DART SERVICE INSTRUCTION

TO AMEND IIN-D139-816 REV. D OR SUBSEQUENT AND ICA-D139-816 REV. 3 OR SUBSEQUENT

REF. TCCA STC: SH12-54 REF. FAA STC: SR03251NY REF. EASA STC: 10045158

1.0 PURPOSE

Figure 1. - RH Side Overhead Panel (shown) (LH side opposite)

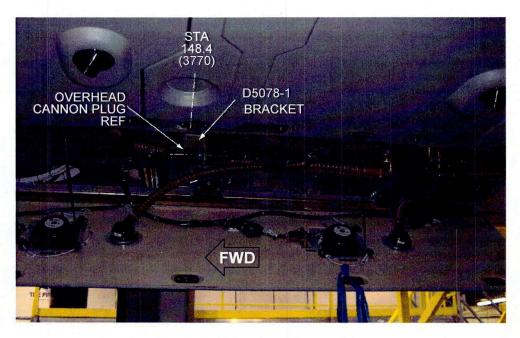
- 2.1 Position D5078-1 Brackets on the RH and/or LH side of the cabin overhead by temporarily removing 2x MS27039-1 screws as shown in Figure 1. Transfer 2x ϕ 0.204" (#6 drill) holes from the airframe to the D5078-1 Brackets. Deburr and touch-up holes with MIL-P-85582 or MIL-P-23377 primer.
- 2.2 Install D5078-1 Brackets using existing 2x MS27039-1 screws and washers as shown in Figure 1.
- 2.3 Install overhead cannon plug in the D5078-1 Brackets using existing NAS1801/1802 screws and existing AS85049/95-20A-A Perimeter Mounting Flange as shown in Figure 2.
- 2.4 Reconnect wire harness to overhead cannon plug as shown in Figure 2.
